**DOCUMENT 00 90 00
ADDENDUM**

ADDENDUM NO. [1] Date: March 7, 2019

**RE: WITC – SUPERIOR CAMPUS
SUPERIOR EXTERIOR PHASE TWO
600 N 21ST STREET
SUPERIOR, WI 54880
HSR PROJECT NO. 18043-1**

FROM: HSR Associates, Inc
100 Milwaukee Street
La Crosse, WI 54603
(608) 784-1830

8 CONCRETE PIER ON GABION FOUNDATION
SCALE: 3/4" = 1'-0"

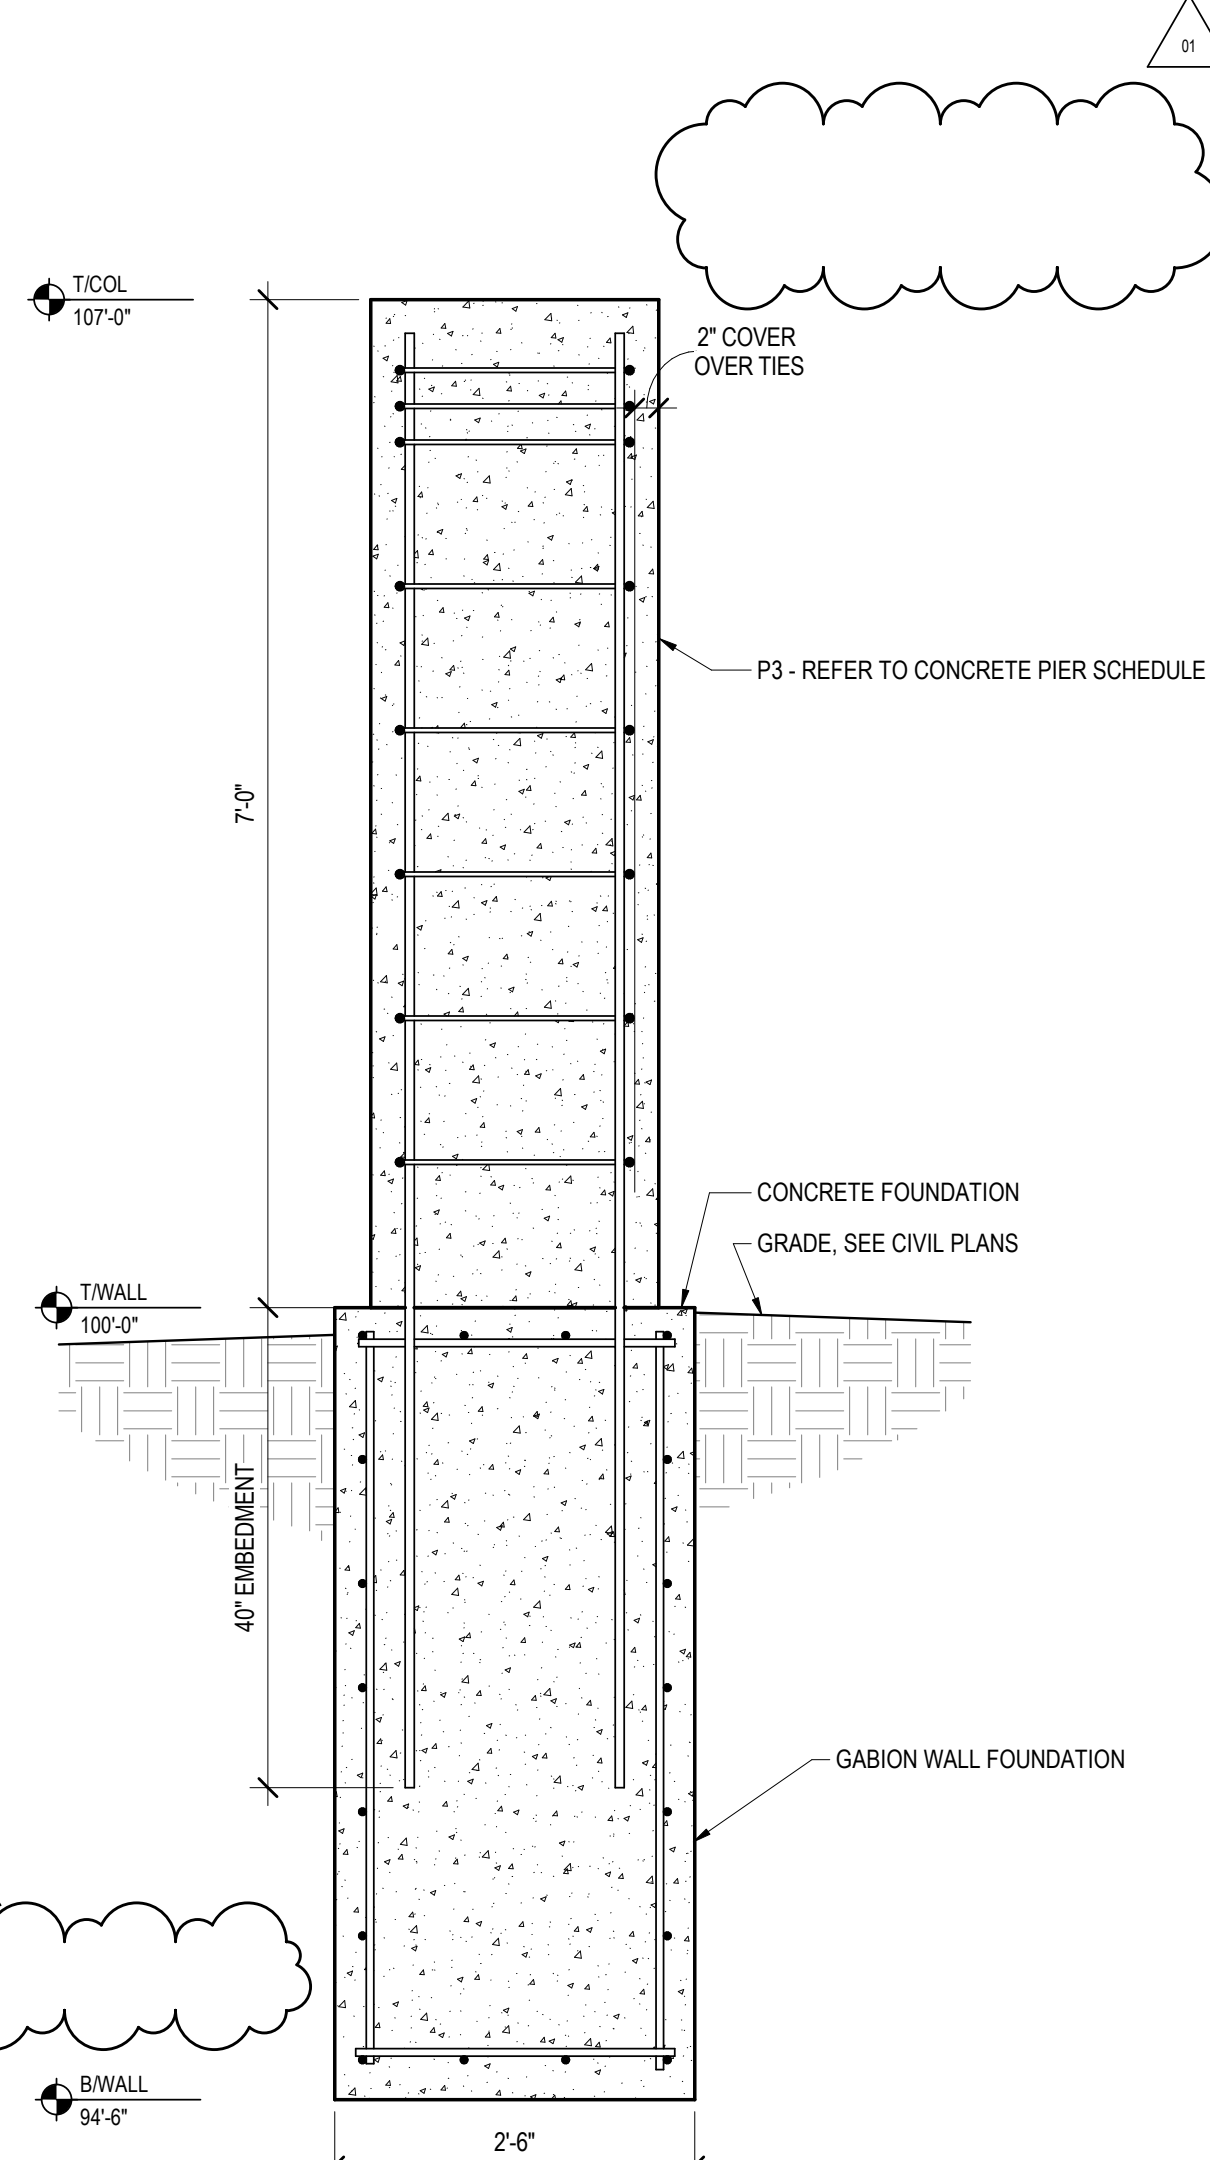
- a. Revisions clouded on Drawing
 - b. Detail 8S200: The pier is intended to be placed in two separate pours. Vertical reinforcing shall be tied to allow for continuity.
